UFE answer to ACER Public consultation on the high-level approach for the identification of alternative bidding zone configurations to be considered for the bidding zone review

Figure 1 – High-level approach for the definition of alternative BZ configurations

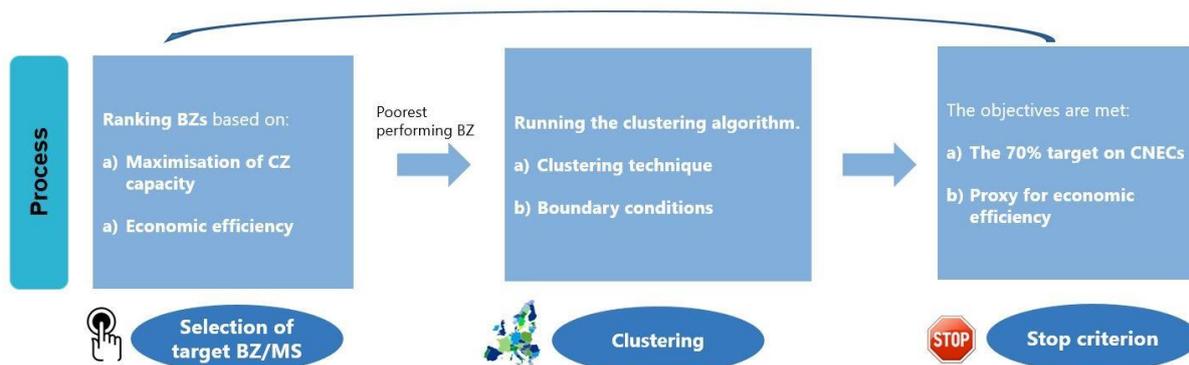
The indicators in question are the one used for selecting/ranking MSs/BZs (step 1) but as well for the stop criterion (step 3). Hence, in the ACER proposal, they are the only drivers for the choice of alternative BZ configurations delineation resulting from splitting MSs/BZs. The reliance on these two indicators used at two different steps of the process creates a risk of inconsistency and non-robustness depending the way ACER implements it concretely, while the precise parameters and thresholds of the approach are not yet published by ACER.

As the approach is presented, the iterative algorithm will only favor a configuration targeting minimal congestions within BZs. UFE believes that only the second indicator proposed by ACER (“dispersion of nodal prices”) is of some relevance for this delineation identification phase but requires further specifications. On the contrary, the first indicator (“amount of internal flows and loop flows contributing to congestions”) is not appropriate since it aims just at assessing BZ configurations with respect to a 70% criteria without any operational security consideration and with a structural assumption about the likelihood of a coordinated capacity calculation and congestion management approach with third countries (as recommended by EC Communication/Guidance on the application of Electricity Regulation 2019/943 Art 16.8) by 2025. For example, while the Trade and cooperation agreement with GB mentions that both parties will make their best effort to reach an agreement in this regard, how should the BZR account for the flows resulting from exchanges between EU countries or Norway and the GB ? are they to be discarded when assessing the 70% MACZT? Moreover, ACER says that it will aggregate the two indicators by weighing equally both indicators to rank BZs, which is questionable. Finally, UFE would like to stress that the stop criterion is very constraining as it stands in the ACER proposal and as well inconsistent with the selection/ranking criterion, since the iterative process of splitting BZs continues, if, after each iteration, both criteria are not met (i.e. the two targets on the two indicators simultaneously).

- The stop criterion proposed (cf. “for all the considered network elements and market time units, the share of internal flows and loop flows taken together is lower than or equal to 23% of the thermal capacity of the network element”) is arbitrary and biased by the current set up on MACZT 70% constraint. This would as well pre-empt the outcome of national plans.

- No value for the stop criterion is mentioned by ACER. With no fixed threshold, the optimum would be a nodal decomposition of the considered BZ/MS.
- The choice of the thresholds below which BZ/MS is selected to be split should be clarified and fixed by ACER before ENTSO-E and TSOs will provide the input data to be used, namely the LMP simulation results. This will prevent any biased choice that would depend on the data themselves. This is for sake of transparency and reliability of the approach.

- Instead of such an iterative process, as introduced in answer to Topic 1, BZ delineations could rather be obtained by using several level thresholds of prices differentials to target different level of congestions (and consequently size of BZ).
